EUROPEAN CENTRAL BANK

T2S CHANGE REQUEST FORM		
General Information (Origin of Request) <input checked="" type="checkbox"/> User Requirements (URD) or GUI Business Functionality Document (BFD) <input type="checkbox"/> Other User Functional or Technical Documentation (SYS)		
Request raised by: Deutsche Bundesbank on behalf of the German NSGs	Institute: Central bank	Date raised: 12/12/2022
Request title: Harmonisation of floor/ceiling notifications with T2		Request No: T2S 0800 URD
Request type: Common	Classification: Scope enhancement	Urgency: Normal
1. Legal/business importance parameter¹: Medium	2. Market implementation efforts parameter²: Low	
3. Operational/Technical risk parameter³: Low	4. Financial impact parameter⁴: Medium	
Requestor Category: Central bank	Status: Allocated to a release

Figure 28 - Breach of floor/ceiling threshold – notification

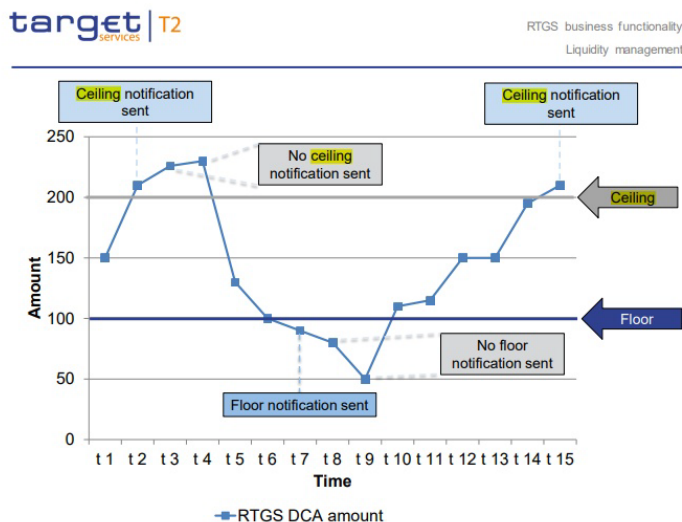
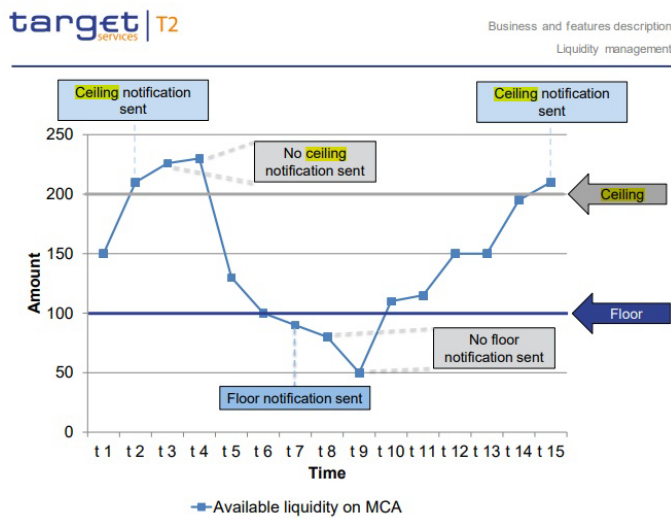
For the T2 CLM/RTGS and TIPS services, the following applies concerning the floor/ceiling notification functionality: The notification is sent only once for every threshold breach, i.e., RTGS/CLM/TIPS does not send the notification again if, after having passed the threshold, the balance of the RTGS DCA/CLM MCA or TIPS DCA remains consistently below the floor or above the ceiling threshold defined.

T2S should be aligned with T2 in order to just send one notification after breaching the threshold. T2S should not send the notification again if, after having passed the threshold, the balance of the T2S DCA remains consistently below the floor or above the ceiling threshold defined.
